**ADVANCED MANUFACTURING PARK - INFRASTRUCTURE MASTER PLAN
CITY OF LACKAWANNA, ERIE COUNTY, NEW YORK**

FINAL GENERIC ENVIRONMENTAL IMPACT STATEMENT
Volume I -FGEIS

September 11, 2020

FIGURE 2

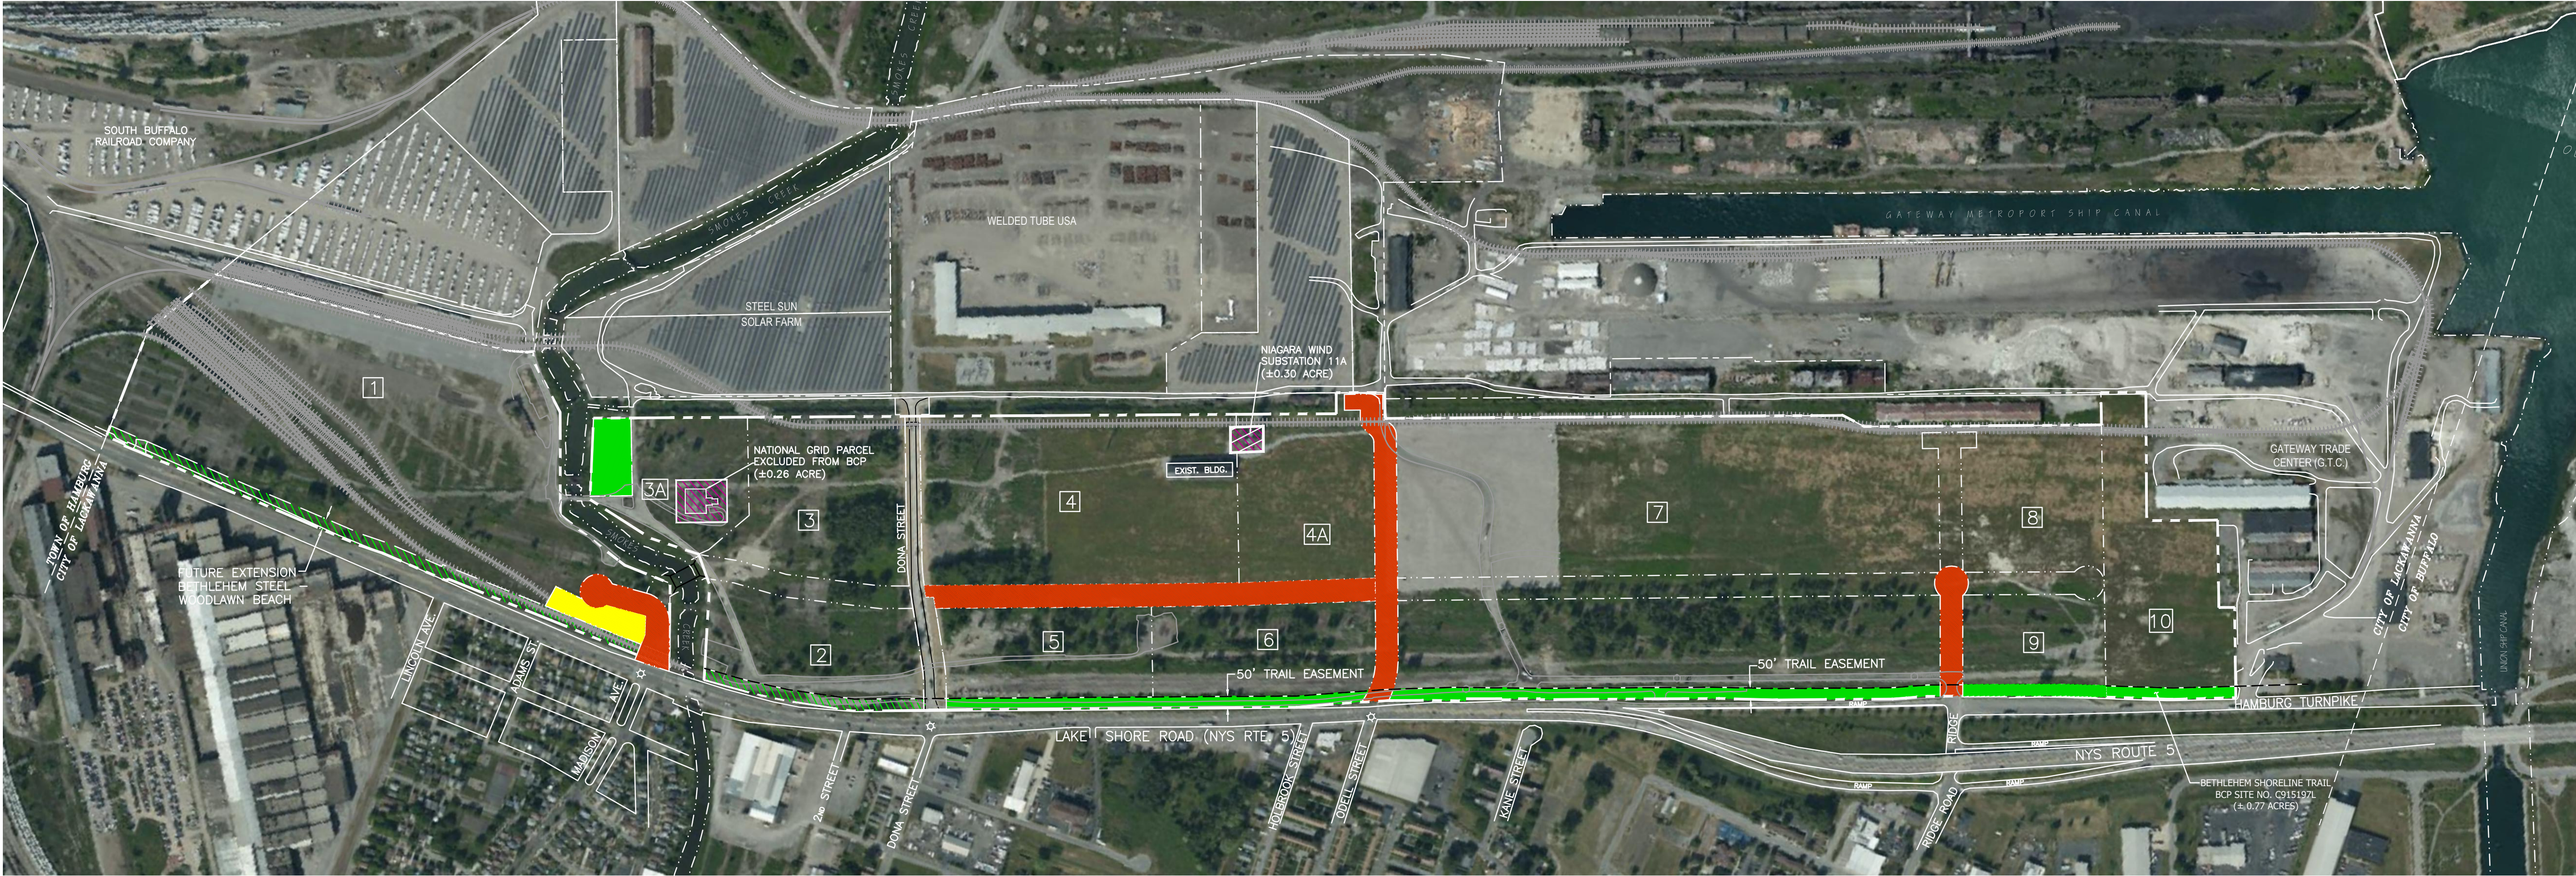
- Page 5: Replace Sheet Number C-2 with Figure 4 (Sheet Number C-2A).
- Page 6:
 - Replace Table 2 with updated 2020 Addendum Table 2 and replace the following text:
